Access Compliance Report

Public Rights-of-Way

(Curb Ramps)

Intersection ID: 30508	Main Street: PLANTERS_ESTATES_DR	Cross Street: SUNRISE_VIEW_DR	Location: SW
ADA ID: 68E8EC385D23	Ramp Type: PerpDiag	Initial Pass/Fail: Fail	Overall Compliance: No
Severity Score: 35			
Codes/Mitigation Info/Possible Solution		Field Measurements/Component Compliance

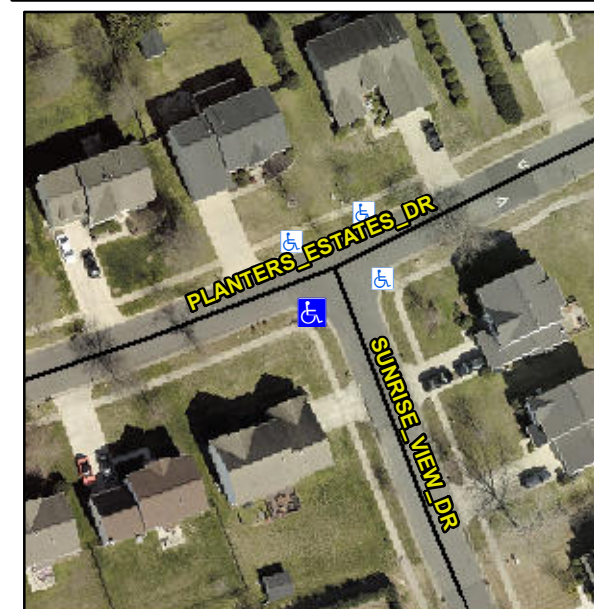
Not Found, R304.5.1, R304.2.2, R304.5.3

Compliance	Description	Data	Compliance	Description	Data
N/A	Ramp Length (in)	87.5	No	Ramp Slope (%)	13.0
No	Ramp Width (in)	46.5	No	Ramp XSlope (%)	2.5
N/A	Flare Type LT	N/A	N/A	Flare Type RT	N/A
N/A	Flare Slope LT (%)	N/A	N/A	Flare Slope RT (%)	N/A
N/A	Flare Traversable LT?	N/A	N/A	Flare Traversable RT?	N/A
N/A	Landing Length (in)	N/A	N/A	DWS Provided?	N/A
N/A	Landing Width (in)	N/A	N/A	DWS Contrast?	N/A
N/A	Landing Slope (%)	N/A	N/A	DWS Length (in)	N/A
N/A	Landing X Slope (%)	N/A	N/A	DWS Full Width?	N/A
N/A	Landing Curb? (Y/N)	N/A	N/A	DWS Offset (in)	N/A
N/A	Shared Landing?	N/A			
N/A	Gutter Ponding?	N/A	N/A	Gutter Slope (%)	N/A
N/A	Gutter Lip Ht (in)	N/A	N/A	Gutter X Slope (%)	N/A
N/A	Painted X Walk1?	No	N/A	Painted X Walk2?	No
	X Walk 1 Direction	To NE		X Walk 2 Direction	To NW
N/A	X Walk 1 Width (in)	N/A	N/A	X Walk 2 Width (in)	N/A
	X Walk 1 Slope (%)	1.3		X Walk 2 Slope (%)	5.1
	X Walk 1 X Slope (%)	3.2		X Walk 2 X Slope (%)	2.2

Remove & Replace Curb Ramp With Two New Directional Ramps or Equivalent.
